# UNITED STATES PATENT AND TRADEMARK OFFICE

APPLICATION NO.	FILING DATE	FIRST NAMED INVENTOR	ATTORNEY DOCKET NO.	CONFIRMATION NO.
10/757,776	01/15/2004	David K. Boehm	06882.0096-00	5457
22852	7590	07/28/2009		
FINNEGAN, HENDERSON, FARABOW, GARRETT & DUNNER LLP 901 NEW YORK AVENUE, NW WASHINGTON, DC 20001-4413				
EXAMINER				
DÖRNBUSCH, DIANNE				
ART UNIT		PAPER NUMBER		
3773				
MAIL DATE		DELIVERY MODE		
07/28/2009		PAPER

### Office Action Summary

## DETAILED ACTION

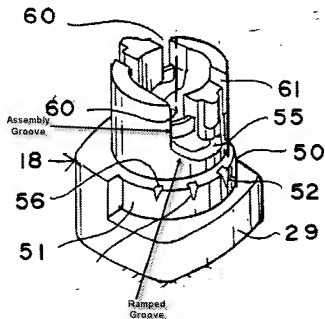
Abulhaj discloses a lancet with an adjustable depth mechanism in which a cap (18) is adjustable by a pin/groove mechanism (Fig. 15-16 where the pin (31) enters the groove seen in the figure below) where the groove has an assembly groove (see figure below) extending in a first direction (it extends longitudinally from the proximal end towards the distal end) and a ramped groove (see figure below) extending in a second direction (it extends diagonally as seen in the figure below) deviating from the first direction (see figure below).

The substitution of one known element (the ramped and assembly groove of the threaded mechanism of Morita) for another (the ramped and assembly groove of the pin/groove mechanism of Abulhaj) would have been obvious to one of ordinary skill in the art at the time of the invention since the substitution of two well known connection mechanisms (pin/groove and threaded) which are used as depth mechanism such as the one shown in Abulhaj would have yielded predictable results of an adjustable depth mechanism.

Additionally, it would have been obvious to a person having ordinary skill in the art at the time the invention was made to provide Morita with the pin/groove mechanism that contains an assembly groove extending in a direction which is deviated from the direction of the ramped groove, in order to have an entry point for the pin which would allow the pin to slid straight through until the ramped groove is reached.

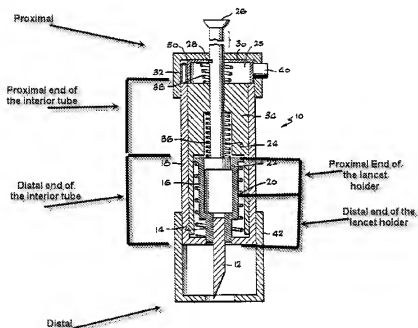
comprising one or more retaining features (retaining features are the walls external of part 14 which compress the lancet in place) and one or more spring surfaces (the outer area and the top surfaces of the lancet holder are spring surfaces since the surface is in contact with the springs) at the distal end (see figure below where the distal end is labeled) and one or more lancet holding features (the internal wall of 14 and 16 as seen in the Figure) at the proximal end (the proximal portion of the holding features is at the proximal end as define din the figure below); an interior tube (34) comprising an open end (proximal end as seen in the Figure) and a slotted end (distal end where it is stepped as seen in the Figure) through which the one or more retaining features extend (see the Figure), the interior tube (34) being adapted to slidably engage the lancet holder (16) (the lancet holder is placed inside the inner tube as seen in the Figure); a finger cover (18) (note that the finger cover according to applicant's drawings is a collar that goes over the interior tube as best seen in Fig. 3 of the current application) arranged along a periphery of the interior tube (see Figure); an internal compression spring (36) comprising a first end and a second end (see Figure), the first end of the internal compression spring (36) being adapted to act on the slotted end of the interior tube (34) (the proximal end of the spring is in contact with the slotted area as seen in the Figure) and the second end of the internal compression spring (36) being adapted to act on the one or more spring surfaces of the lancet holder (16) (the distal end is in contact with the lancet holder so when a force is applied on the spring it will act on the spring surfaces); a retainer (14) comprising a slotted surface (it has a slot in the center where the lancet is slid through) at the distal end of the interior tube (see figure below)

through which the one or more retaining features extend (see the Figure); a rearward body (combination of 24 and 22), the rearward body engaging the retainer (14) (when the rearward body is displaced in the forward direction it will engage with the retainer); wherein longitudinal movement of the rearward body away from the interior tube compresses the interior compression spring (36) (by pulling on the rearward body it can compress the interior tube) (Col. 3 Lines 5-10) and an external compression spring (20) comprising a first end and a second end (see the Figure), the first end comprising a reduced coil diameter that engages the one or more retaining features (14) of the lancet holder (16) as seen in the Figure, the first end of the external compression spring being adapted to act on the lancet holder (the spring is holding the lancet holder which will act on it to cause the deployment of the lancet) and the second end of the external compression spring being adapted to act on the slotted surface of the retainer (the spring is compressing on the retainer therefore it is acting on the slotted surface); and wherein the one or more spring surfaces of the lancet holder engages both the internal compression spring and the external compression spring (see Figure where the one or more spring surfaces engages indirectly to both spring).

not at the proximal end. The examiner disagrees as explained in the rejection and drawing above. Note that the applicant did not disclose a specific definition of the distal and proximal ends of the device with respect to the components of the device therefore the examiner broadly interpreted it and defined the distal and proximal end as seen in the drawing above.
